Appendix I

Public Comments and Responses on Draft Integrated Document

I.1 Purpose of the Response to Comments

Figure I-1. WPCP South – Drying Beds

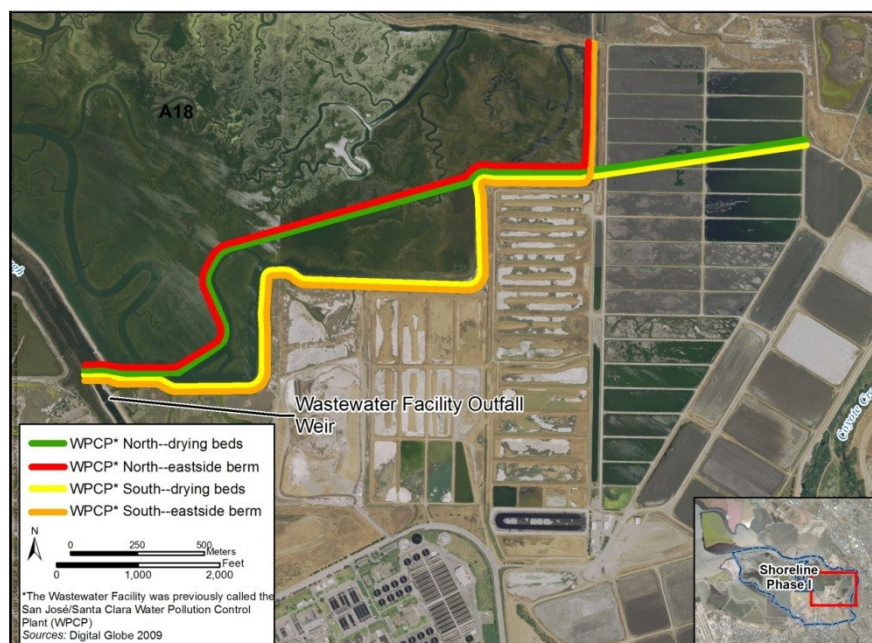
Multiple letters state that the Shoreline Study team prematurely dismissed a variation of the levee alignments that would move the last “leg” of the eastern-side of the Pond A18 levee from its northern terminus (shown in orange in Figure I-1 *Potential Wastewater Facility Segment Levee Alignments*) on the Coyote Creek Flood Protection levee, to a more eastern terminus (shown in green) on the Coyote Creek Flood Protection levee further upstream. In either terminus location, the Shoreline levee would tie into the Coyote Creek flood protection levee which is FEMA certified to provide 100-year fluvial flood protection.

The eastern terminus alignment was not carried forward as a feasible alternative for consideration in the draft EIR/EIS (referred to in this document as an Integrated Document as combined with the USACE Interim Feasibility Study) because the City of San Jose's current plan for the San Jose-Santa Clara Regional Wastewater Facility (Wastewater Facility) is to retain the existing sludge lagoons which currently occupy the area needed to implement an eastern terminus alignment. The City of San José adopted the Plant Master Plan (PMP) for the Facility in November 2013. The PMP is a planning document to guide improvements at the plant for the next 30 years, including defining future treatment needs and designating future land use on plant lands. The PMP identified a tentative levee alignment which would allow the Facility's continuous use of the sludge lagoons for the dewatering treatment process. The eastern terminus alignment would require the removal of some of the lagoons. In preparing the response to this comment, the Shoreline team re-engaged the City of San José staff to solicit additional information about their operations and long-term preferences. The City of San Jose is currently conducting an evaluation of the odor impacts of the Facility's operations, including the sludge lagoons, on the surrounding community and the feasibility of using other waste processing technology. Once the study is concluded, the City will be able to analyze its future operations and possibly determine whether or not it will continue to use the sludge lagoons. While the City of San José will continue to work with the Shoreline Phase I team to determine the final levee alignment, given the uncertainty surrounding the Wastewater Facility's future need for the sludge lagoons, it is speculative at this time to consider the suggested eastern terminus alignment as a feasible alternative for further review in the Integrated Document.

Figure I-2. Potential Artesian Slough Crossing Options

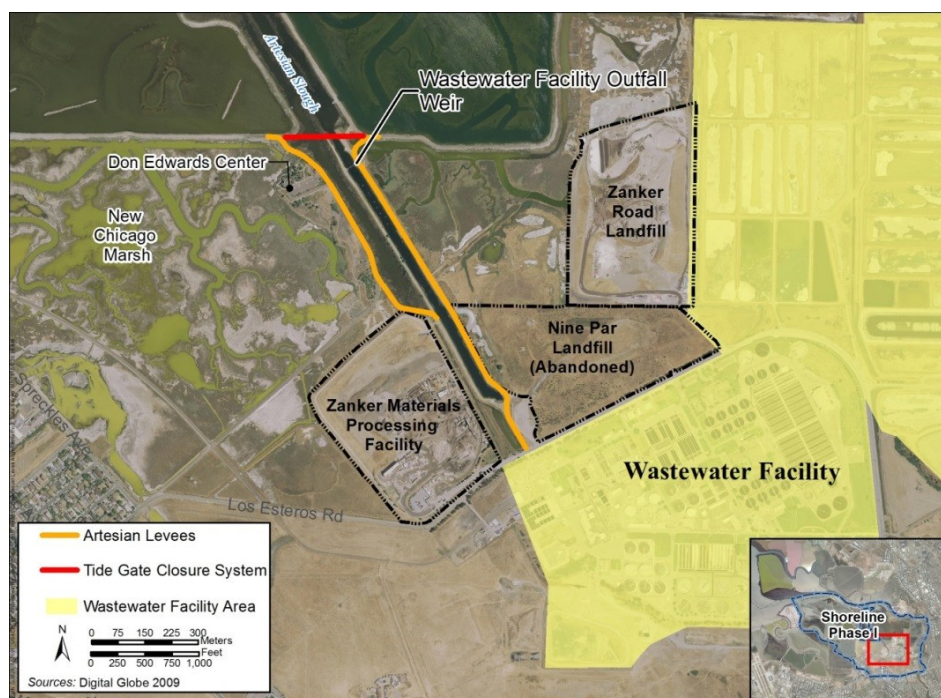
- Whether closing flood gates downstream of the Wastewater Facility's effluent discharge is feasible
- Impacts to the Wastewater Facility's treatment process
- Conversion of aquatic habitat in Artesian Slough due to freshwater discharges from the Wastewater Facility or adding an obstruction in the slough that may alter the salinity
- Direct fill of Artesian Slough for the tide gate.

As stated in the draft Integrated Document, the measure that includes constructing levees up either side of Artesian Slough to high ground was not carried forward for further analysis because “it is less economically efficient than the tide gate measure and did not provide any additional advantages relative to the other criteria.” Additional analysis was conducted on the alternative to extend levees down both sides of Artesian Slough (as depicted in Figure I-2 *Potential Artesian Slough Crossing Options*) that was not included in the draft Integrated Document.

The Shoreline Phase I Study team determined that a tide gate at Artesian Slough was the environmentally preferred concept based on currently available information. Additional information has been added to Chapter 3 of the Integrated Document to provide additional details about the flood gate.

Figure S-1. South San Francisco Bay Shoreline Interim Feasibility Study Areas

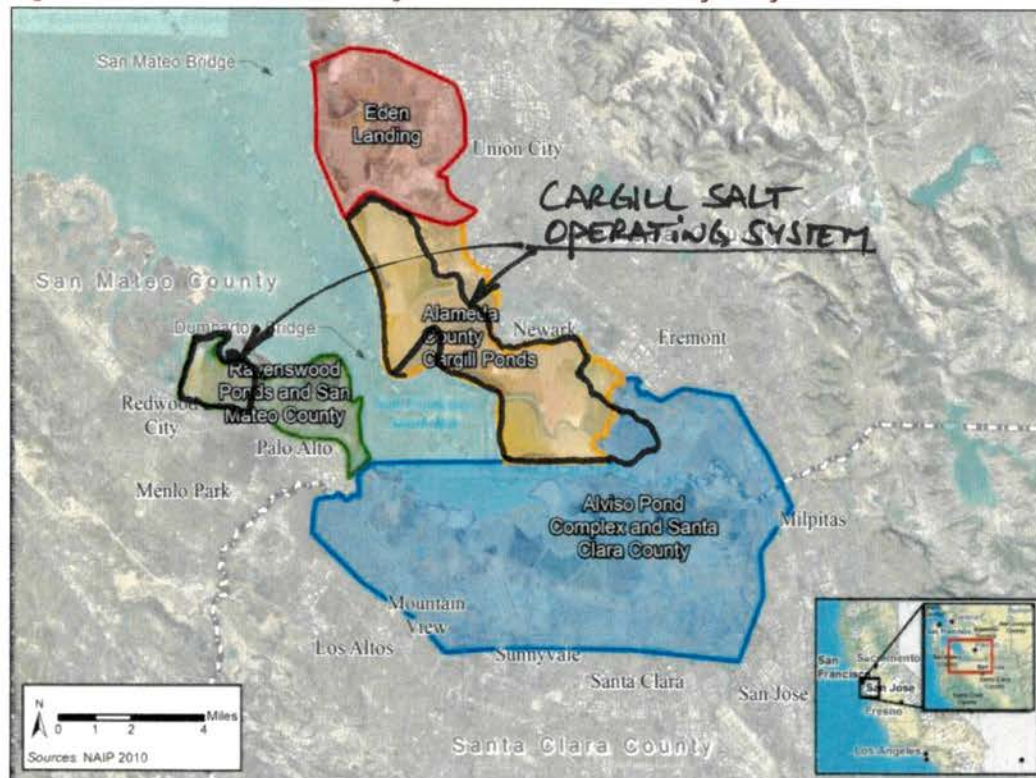
1. Figure S-1. South San Francisco Bay Shoreline Interim Feasibility Study Areas

ID	Issue Text	Response Text
040_CG-1	Figure S-1. South San Francisco Bay Shoreline Interim Feasibility Study Areas. This figure needs both a change in nomenclature as well as a line-shading adjustment. The border around the property labeled "Alameda County Cargill Ponds" is inaccurate. It fails to include our operating salt ponds 4 & 5, which are currently shaded blue and shown as part of the "Alviso Pond Complex and Santa Clara County". The orange shaded area also includes EBRPD's Coyote Hills - this needs to be removed from the map. Lastly, Cargill's Redwood City Plant Site needs to be distinguished from the "Ravenswood Ponds and San Mateo County". All of Cargill's property should be labeled "Cargil Salt Operating System". I have attached an edited map as Exhibit 1 for your reference.	Thank you for clarifying the boundaries of the individual feasibility study areas and the Cargill Salt operating system ponds. The suggested revisions to the Figure (now Figure1.5.1) has been made per the edited map provided as an attachment to your letter. The Executive Summary was shortened and the Figure no longer appears there.

Figure 1.4-1. South San Francisco Bay Shoreline Interim Feasibility Study Areas

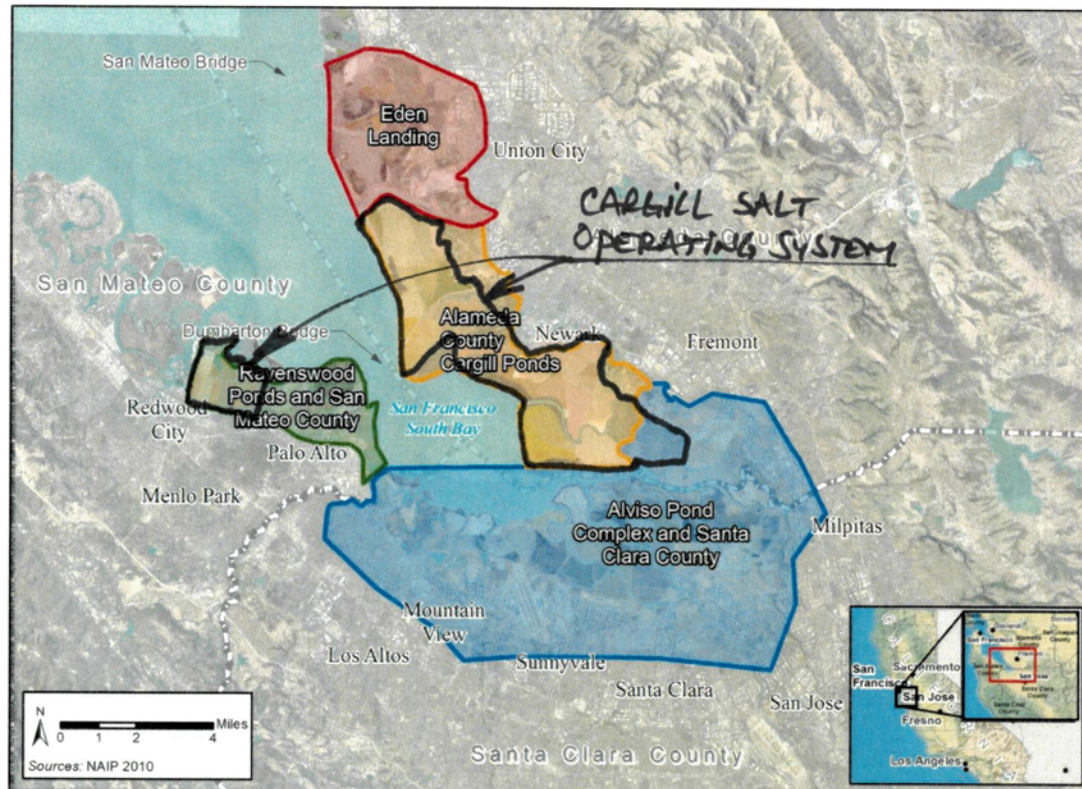
3. Figure 1.4-1. South San Francisco Bay Shoreline Interim Feasibility Study Areas

This is the same figure as Figure S-1. Please see comment #1 for details. I have attached an edited copy of this page as Exhibit 3 for your reference.

040_CG-2	Chapter 1, page 1-6, 2nd paragraph - In the middle of this paragraph, the sentence reads, "However, in 2003, the Federal and State governments acquired 15,100 acres of inactive (former) salt ponds in the South Bay from Cargill Salt..." Please note that in 2003, these salt ponds were in fact "active". Please correct the sentence to read, "However, in 2003, the Federal and State governments acquired 15,100 acres of active salt ponds..." I have attached an edited copy of that page as Exhibit 2 for your reference.	The suggested revision to Chapter 1 has been made. The sentence has been revised as requested. Additionally, further in the same sentence, the term "former" was removed in reference to the salt pond dikes themselves.
040_CG-3	Figure 1.4-1. South San Francisco Bay Shoreline Interim Feasibility Study Areas. This is the same figure as Figure S-1. Please see comment #1 for details. I have attached an edited copy of this page as Exhibit 3 for your reference.	Thank you for clarifying the boundaries of the individual feasibility study areas and the Cargill Salt operating system ponds. The suggested revision to Figure 1.4-1 (now Figure 1.5-1) has been made per the edited map provided as an attachment to your letter. The Executive Summary was shortened and the Figure no longer appears there.

Figure 4.4-2. Estimated Bathymetry at Year 50 (2067) Based on the Modeling and Analysis by Brown (2010)

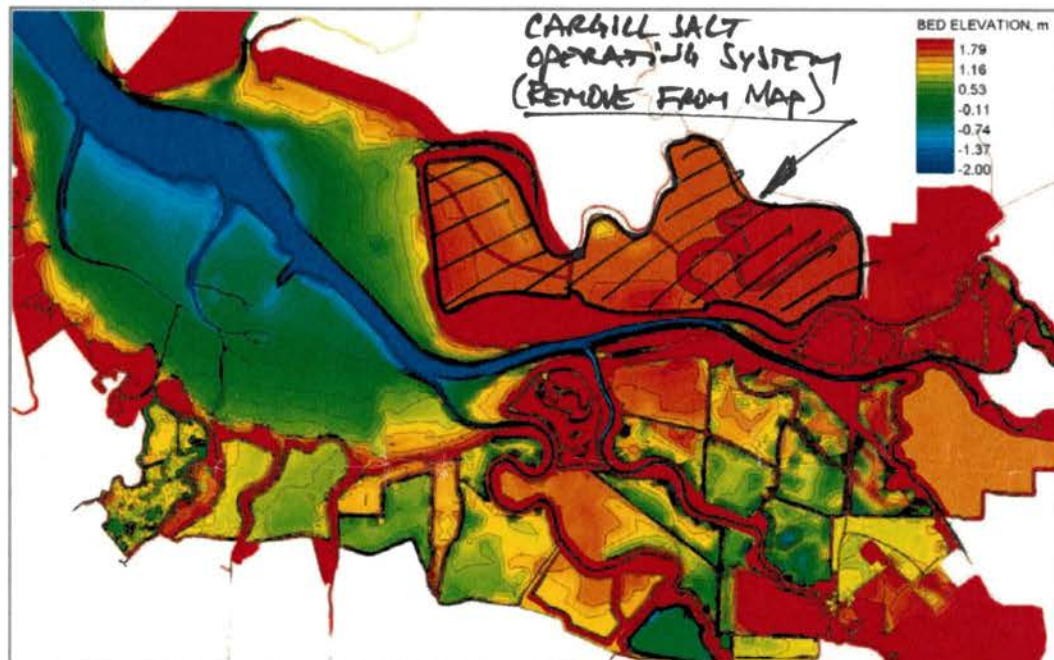
4. Figure 4.4-2 Estimated Bathymetry at Year 50 (2067) Based on the Modeling and Analysis by Brown (2010)

This figure shows an estimated bathymetry at year 50 in Cargill’s operating ponds 1, 2, 3, 4, 5 & 6. Since this is outside the study area and within Cargill’s continue operating ponds, please remove this from the map. It erroneously shows a bathymetric change in Cargill’s operating ponds as if they were being subject to tidal action – which they are not, nor are they planned to be. Please see the attached edited page as Exhibit 4 for your reference.

040_CG-4	Figure 4.4-2 Estimated Bathymetry at Year 50 (2067) Based on the Modeling and Analysis by Brown (2010)This figure shows an estimated bathymetry at year 50 in Cargill's operating ponds 1,2,3,4,5 & 6. Since this is outside the study area and within Cargill's continue operating ponds, please remove this from the map. It erroneously shows a bathymetric change in Cargill's operating ponds as if they were being subject to tidal action - which they are not, nor are they planned to be. Please see the attached edited page as Exhibit 4 for your reference.	Thank you for clarifying the boundaries for the estimated bathymetry at year 50 (Figure 4.4-2). The referenced ponds have been removed from the figure and the bathymetric change has been limited to those areas in the study area that will be subject to tidal action.
